42 HONEYSUCKLE DRIVE COTTAGE CREEK PRECINCT NEWCASTLE

NEWCASTLE CITY COUNCIL
DEVELOPMENT APPLICATION

ARCHITECTURAL DESIGN STATEMENT

SUMMARY OF PROPOSED AMENDMENTS

5.3 DESIGN CHANGES FIFTH FLOOR

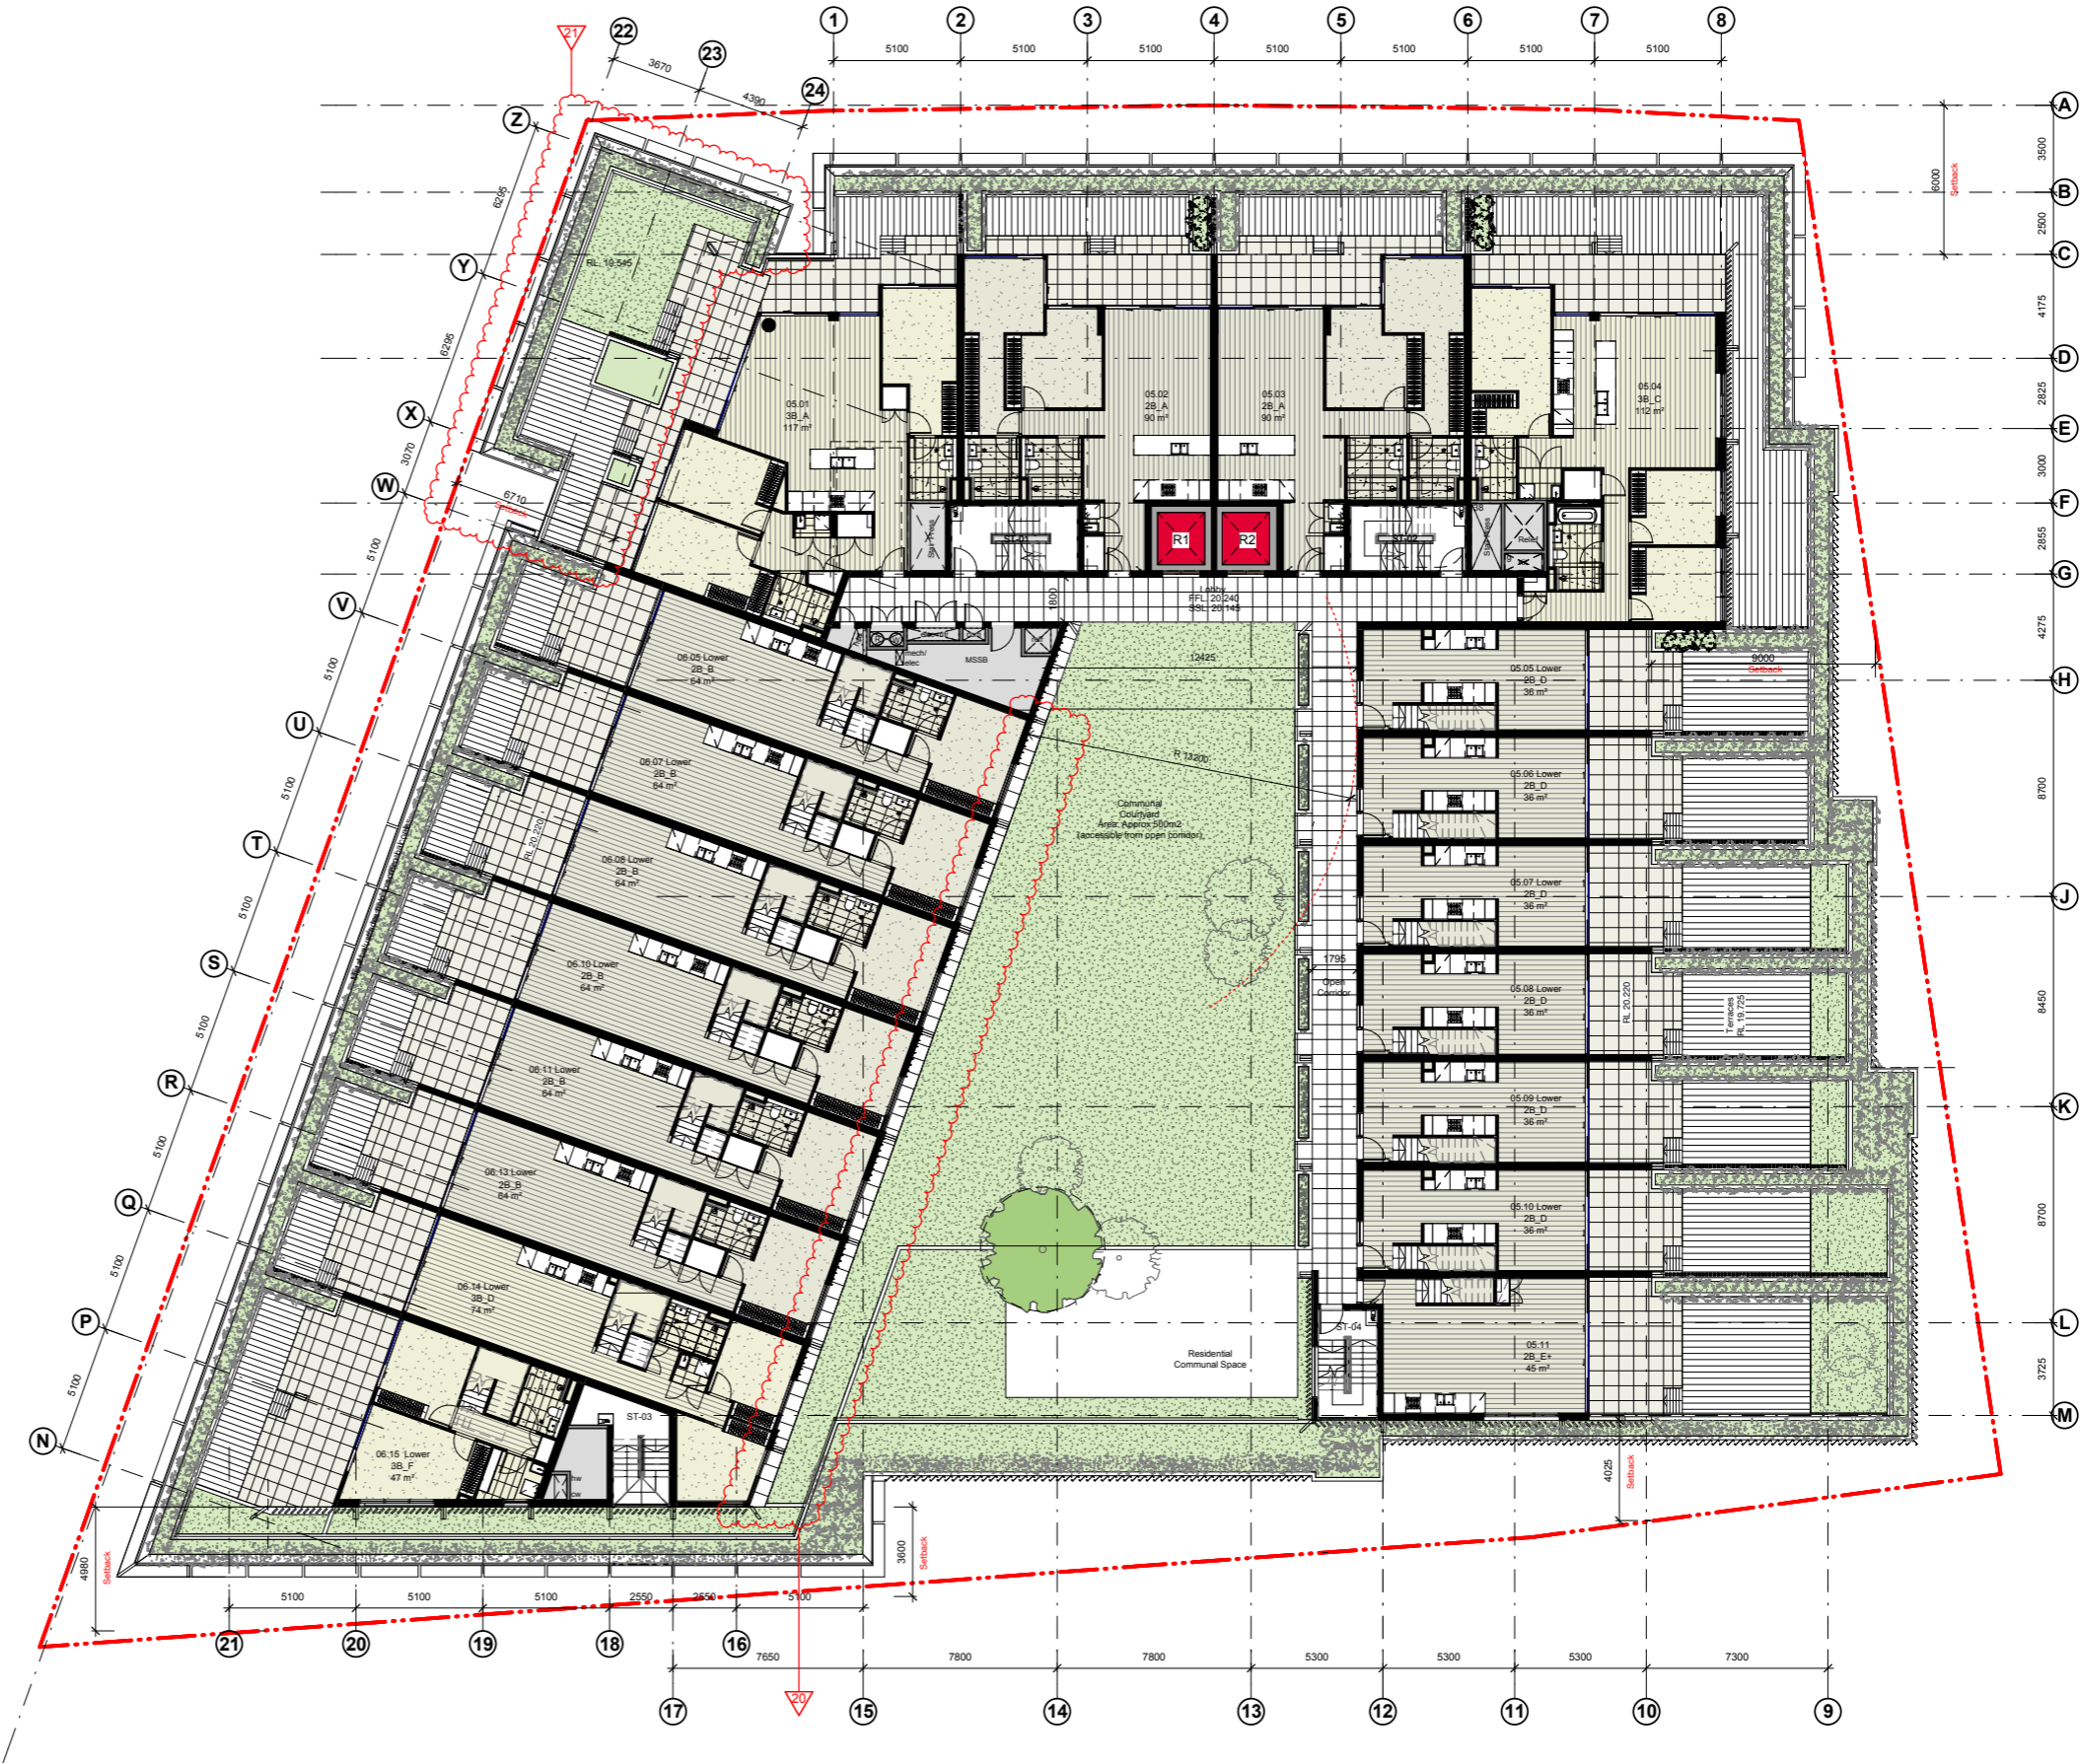
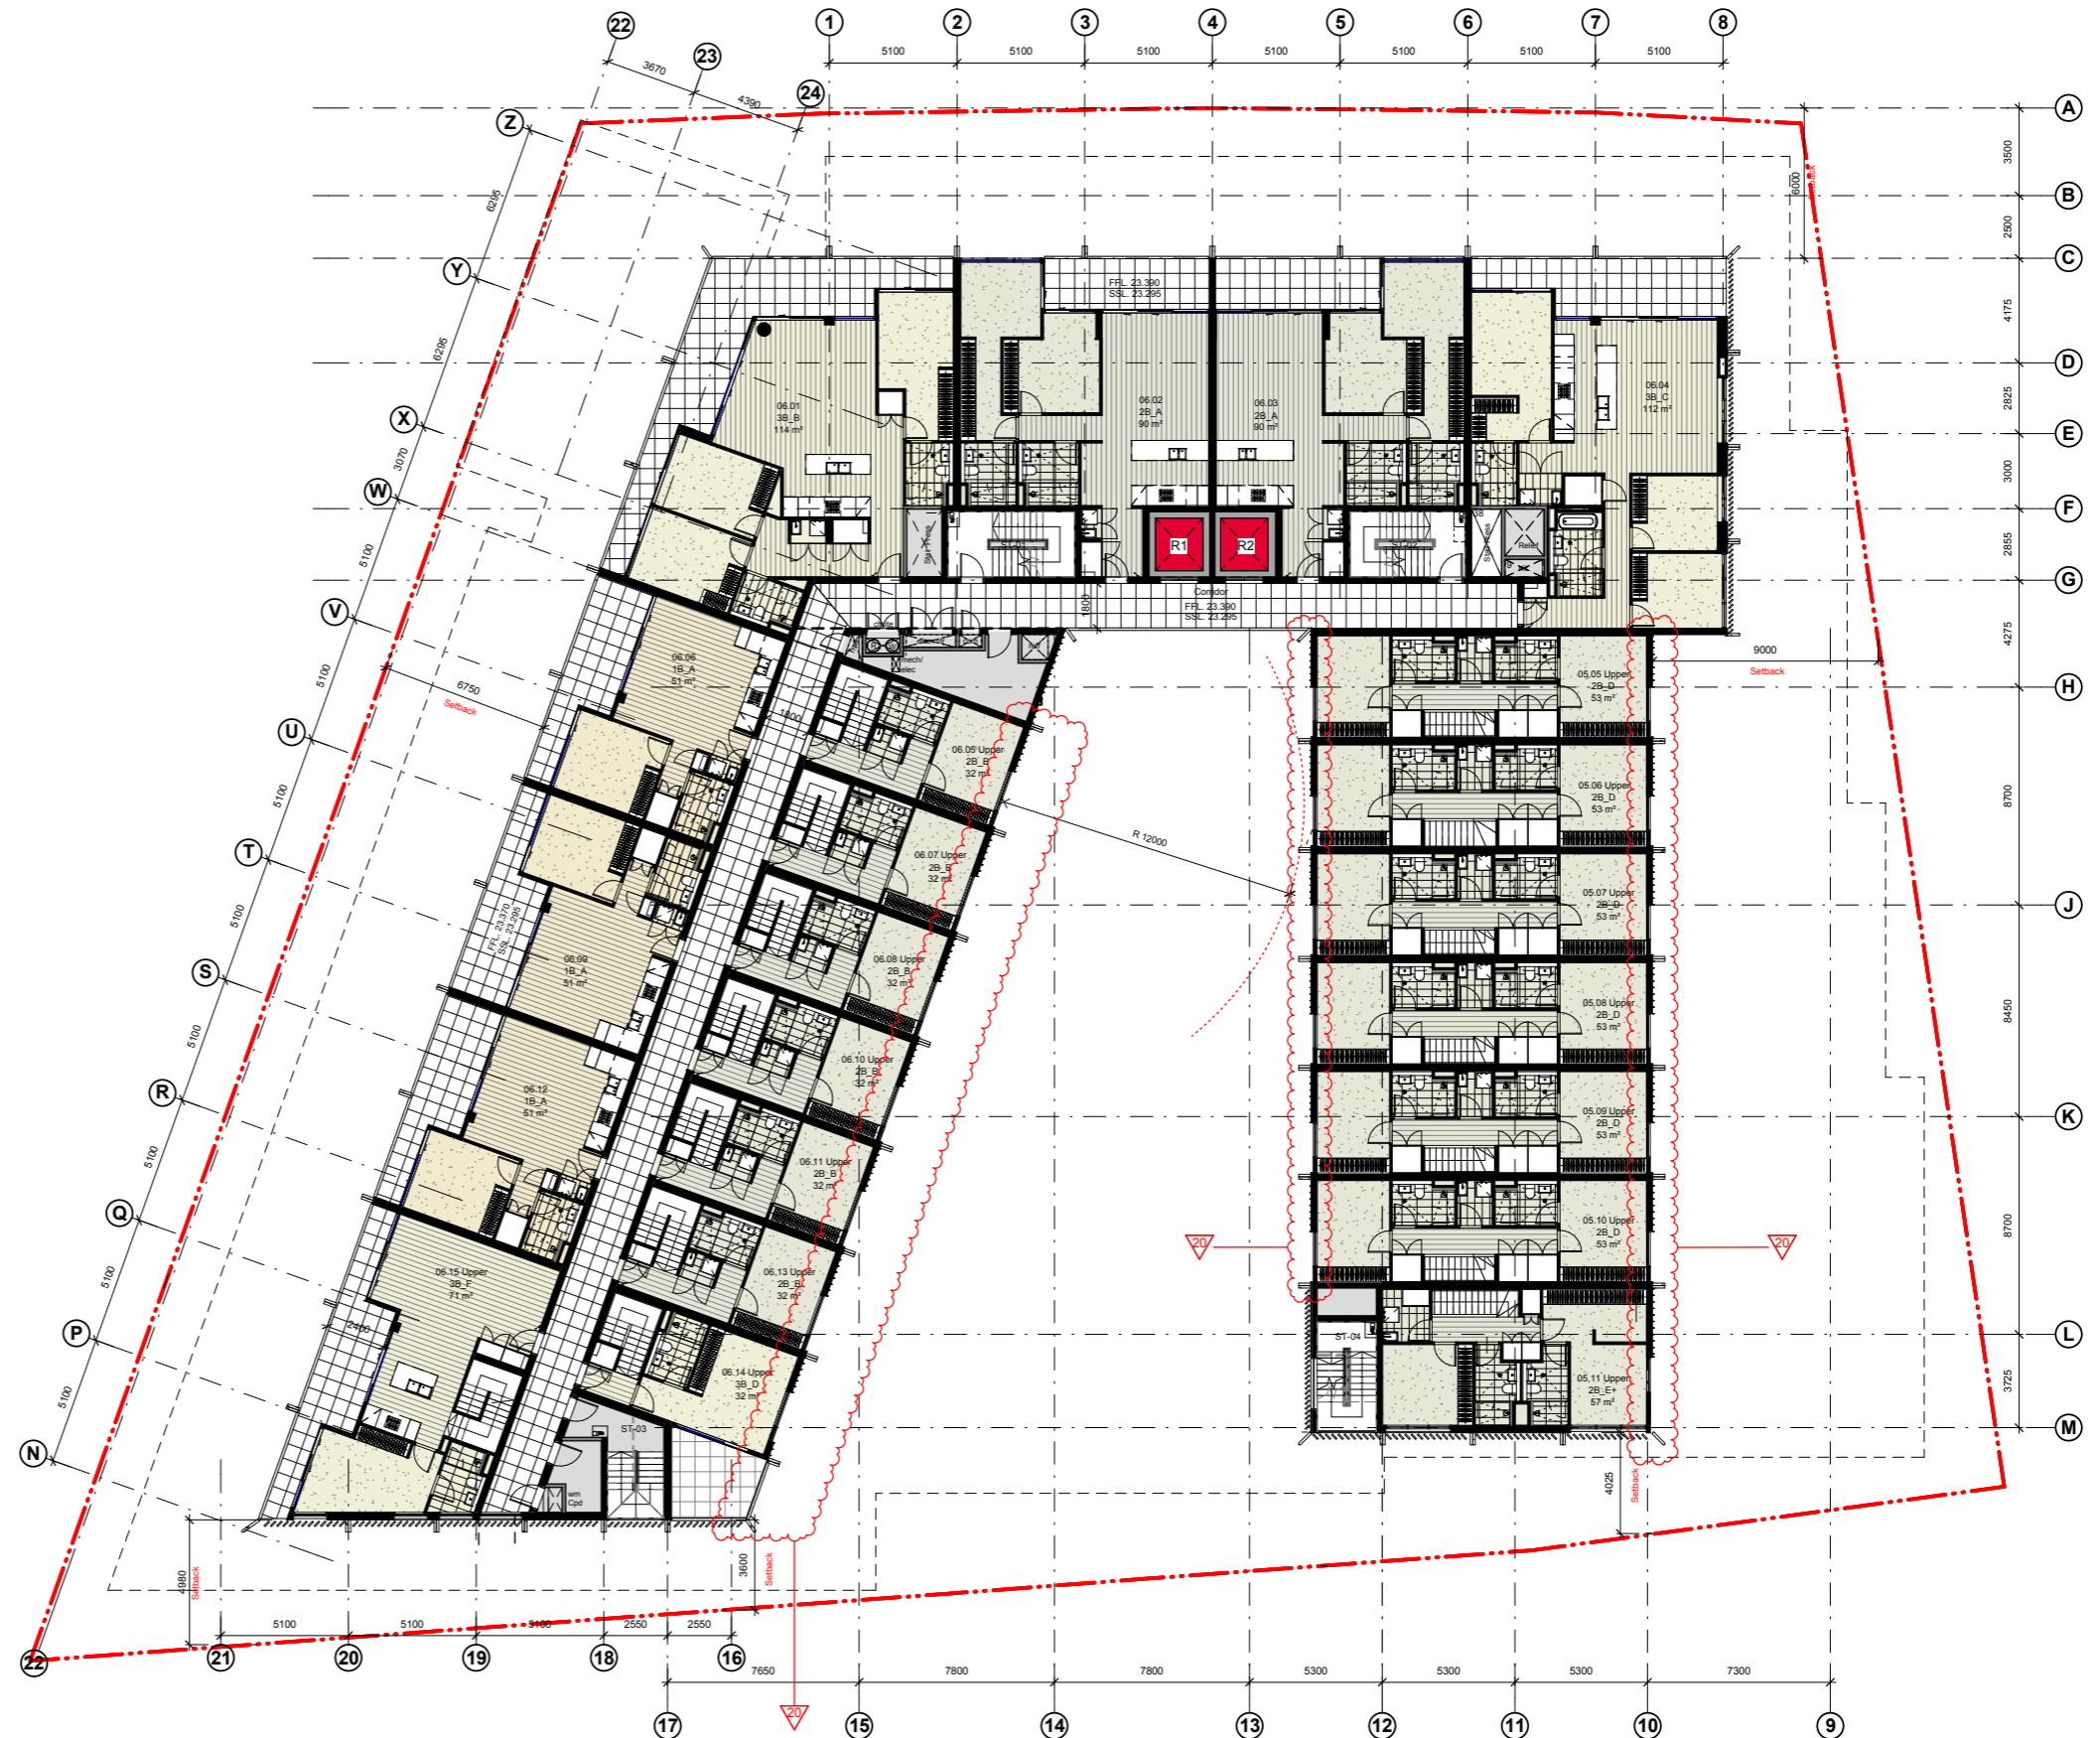
- 1 / Accommodation on Levels 05-08 amended from 52 residential apartments to 60 serviced apartments.
- Modifications to the south eastern building volume from Level 05 to 08 in response to the revised apartment typology

- Adjustments to the facade design from Level 05-08 in reponse to the revised apartment typologies. General materiality and facade components have been retained from the previously approved design.

- Modifications to the landscaped courtyard design on Level 05 to suit the revised envelope and orientation of serviced apartments.
- Adjustments to the extent of landscaped planters to Level 05.

- 2 / Adjustments to the location of the south western fire stair. To accommodate the revised serviced apartment floorplate, the fire stair shifts to the west by one hotel bay. Facade treatment from Ground to Level 04 are adjusted to suit.

- 3 / Adjustments to the location of the south eastern fire stair. To accommodate the revised serviced apartment floorplate, the fire stair shifts to the east. Facade treatment from Ground to Level 05 Parking are adjusted to suit.
